**RFP TITLE: CAMERON COUNTY 835 EAST LEVEE & SAN BENITO ANNEX
BUILDING STANDBY POWER UPGRADES**

RFP NUMBER # 230704

July 21, 2023
 Cameron County 835 East Levee & San Benito Annex Building
 Standby Power Upgrades

ADDENDUM NO. 2

1) Sheet LE2.3:

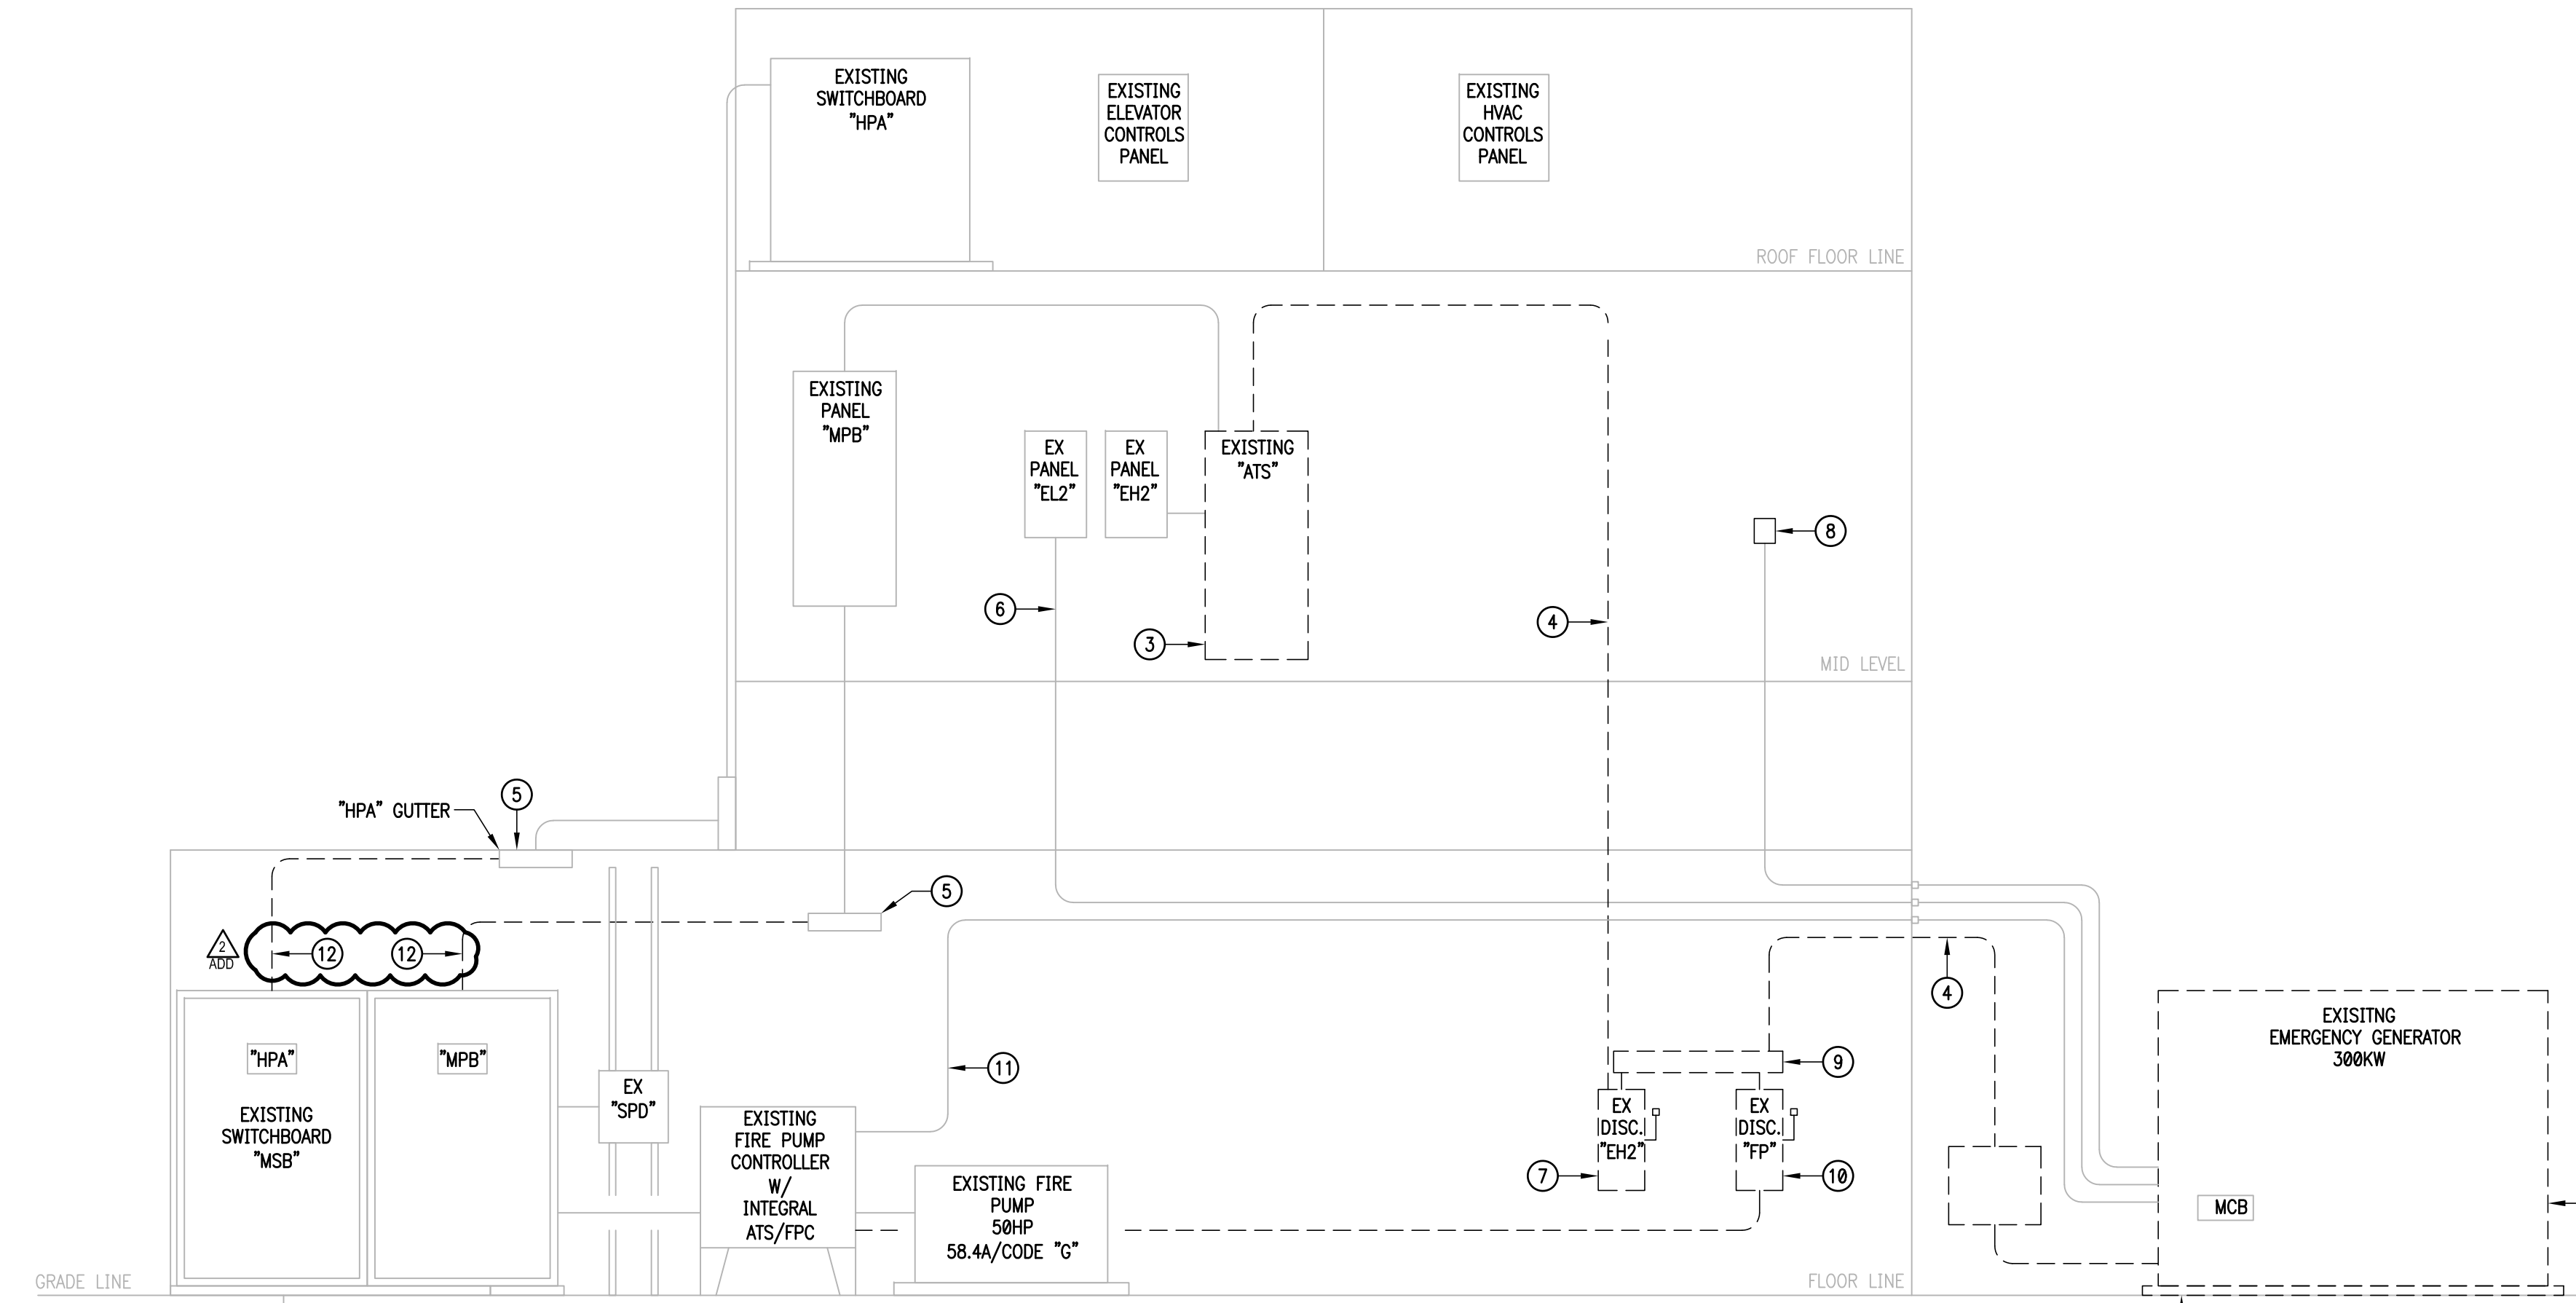
- a) Replace HVAC Controls General Notes on their entirety with the following:
 - i) Existing HVAC Building Automation System is by Automated Logic Controls (ALC). Contact ALC for all work associated with HVAC Controls. Building will be equipped with a new generator to provide emergency power during a normal power outage. Intent is that chillers and pumps start-up staggered and in an orderly fashion to avoid problems with generator start-up.

- ii) Existing Sequence of Operation specification calls for the following parameters and setups that shall prevent all pumps and chillers from starting-up at the same time. This staggering and sequencing are critical for the proper start-up of generator. BAS shall always retain this setup including after a power outage and/or during generator emergency power:

- (1) Minimum delay between on/off commands for Pumps and Chillers to prevent short cycling. 10 minute delay (adjustable) for Pumps and 15 minute delay (adjustable) for Chillers.

- (2) In sequence, enable lag chiller and associated chilled water pump under the following conditions when lead chiller cannot meet load:
 - (a) If chilled water supply temperature cannot be maintained (rises 1°F above setpoint), and chiller load is above 90% (adj.) and remains there for preset time delay. To prevent short cycling of chillers, ensure that a minimum run time of 15 minutes is programmed.

- (b) First 30 minutes chiller plant is enabled for the day: Allow the lead chiller sufficient time, 30 min (adj) to attain CHWST setpoint.
 - (c) After the first 30 minutes, the delay to start the lag chiller shall be 10 minutes (adj).

iii) ALC shall test, recommission, document, and demonstrate that proper sequencing and operation of the delays in pumps and chillers are programmed and in place as described above. General Contractor shall coordinate all activities associated with this work and include all costs in the base bid.

02 835 EAST LEVEE BUILDING
NEW ELECTRICAL RISER DIAGRAM
SCALE : NONE

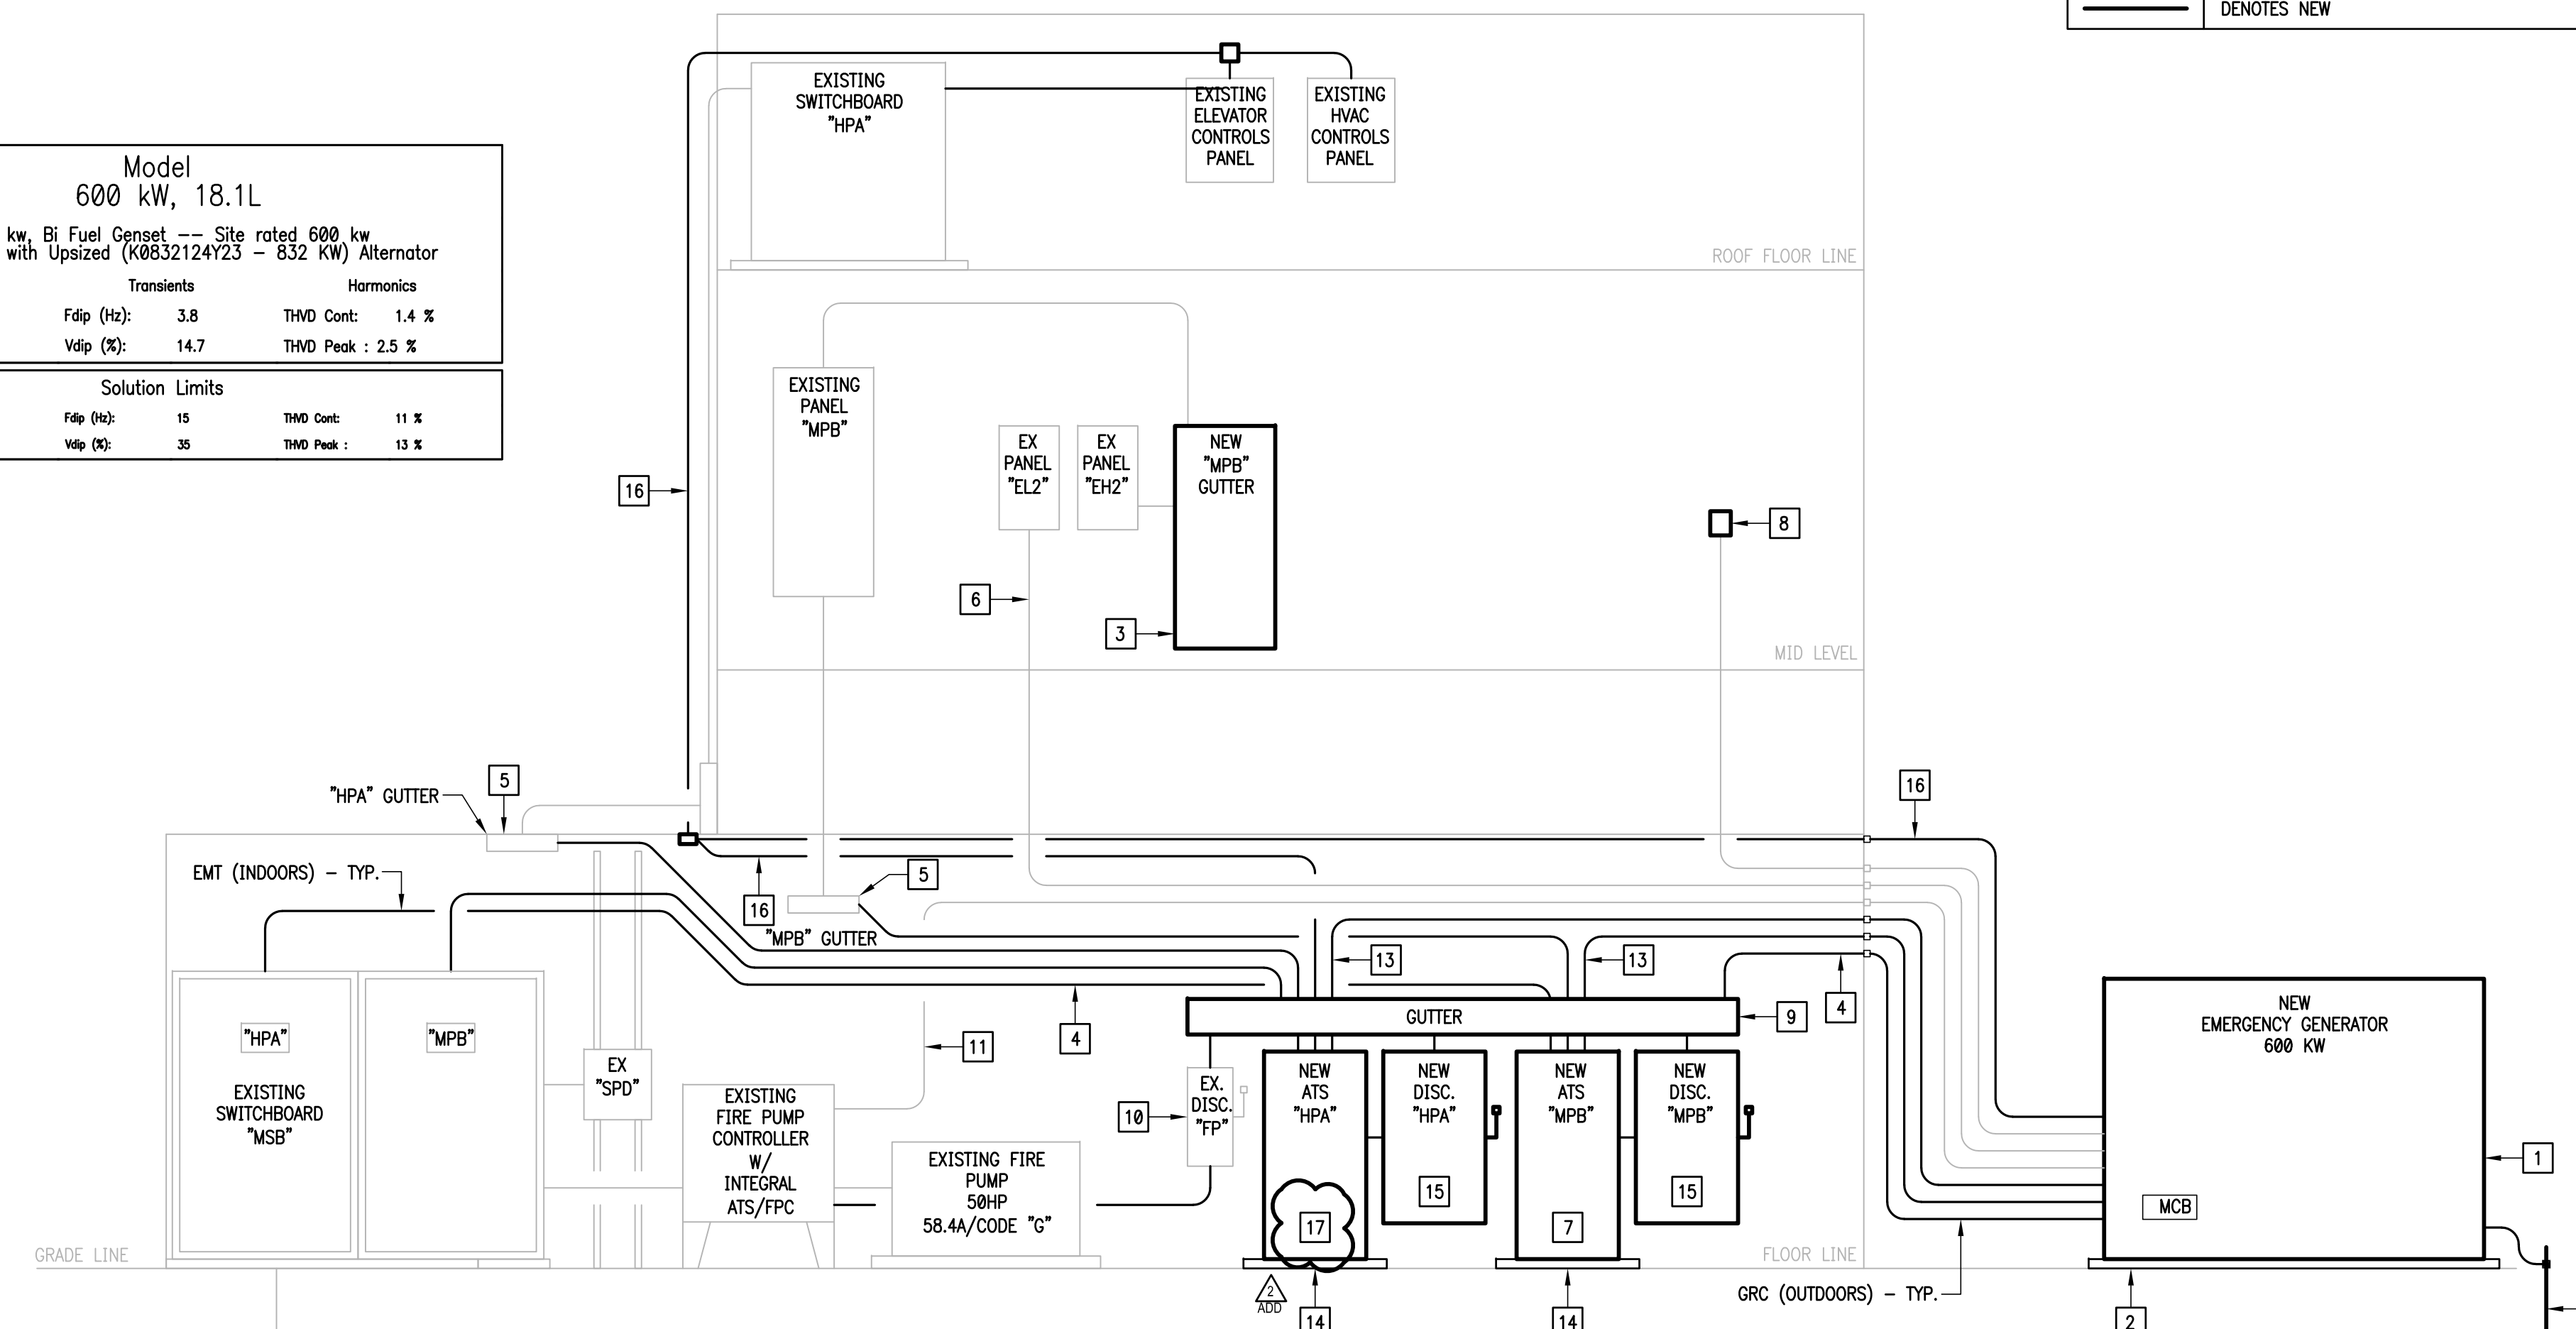
i) On the feeder schedule (LE3.1) Feeder Runs from the ATS “HPA” to the existing “HPA” Gutter” are shown as 1200A, but ATS “HPA” and Disconnect “HPA” are called out as 800A. Please verify that ATS “HPA” and Disconnect “HPA” sized at 800A is the intent.

ii) On the feeder schedule (LE3.1) there is a callout for 1200A feeding the Gutter. Please verify that this run is from the New Generator to the Gutter.

iv) The feeder schedule shows two separate feeders for MPB Gutter. One is copper conductor and the other is aluminum conductors. Please verify if the intent is to use copper or aluminum.

2) Sheet LE3.1:

a) Revised Electrical Riser Diagrams. See attached sheet.

Response: ATS and Disconnect “HPA” to be sized for 1200A. The electrical building load would be managed under emergency power.

Response: The feeder from the Generator to the Gutter is 1200A.

Response: The intent is to be aluminum from “MPB Gutter” to ATS “MPB”.
